#### SCE FOURTH SET OF COMMENTS ON DPV2 DEIR/DEIS

### SCE COMMENTS ON DPV2 DEIR/DEIS PORTRERO ACEC, AUGUST 2006

### Comment Set E4, cont. Southern California Edison Company

### Harquahala Mountain Communication Site Project Description

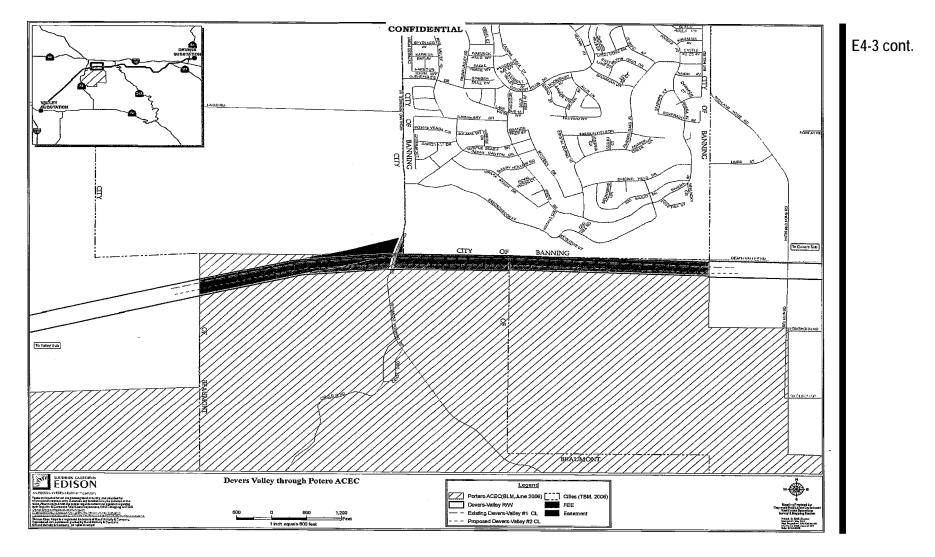
| Section | Page  | Line                   | Comment   | Remarks/How Suggested to<br>Resolve  |
|---------|-------|------------------------|---|--|
| ES4.4.2 | ES-43 | Paragraph<br>3, Line 6 | The Devers-Valley No. 2 Alternative route proposed<br>by the CPUC in the DEIR/DEIS parallels SCE's<br>Devers-Valley No. 1 line. As the route nears the  | SCE believes and requests that<br>the Devers-Valley No. 2<br>transmission line ROW across the  |
| C.4.3   | C-26  | Paragraph<br>1, Line 7 | cities of Beaumont and Banning along the southern<br>San Jacinto foothills, it crosses the current northern<br>boundary of the BLM's Portrero ACEC. SCE has an<br>existing right-of-way (ROW) across the ACEC both<br>in fee and in easement as shown in the enclosed<br>figure. SCE's ROW existing grants allow the<br>construction and operation of the Devers-Valley No.<br>2 line across the ACEC. The current boundaries of<br>the ACEC were recently expanded to include the<br>area where the lines cross the current ACEC<br>boundaries. SCE had acquired these ROWs prior to<br>the ACEC expansion and is has legal ROW<br>permission to build the Devers–Valley No. 2 line. | Portrero ACEC should not be<br>under BLM jurisdiction since the<br>ROW was obtained by SCE prior<br>to establishment of the new<br>boundaries that now include the<br>line. Also, SCE' has existing fee<br>and easement ROWs that allow<br>construction of the line. |
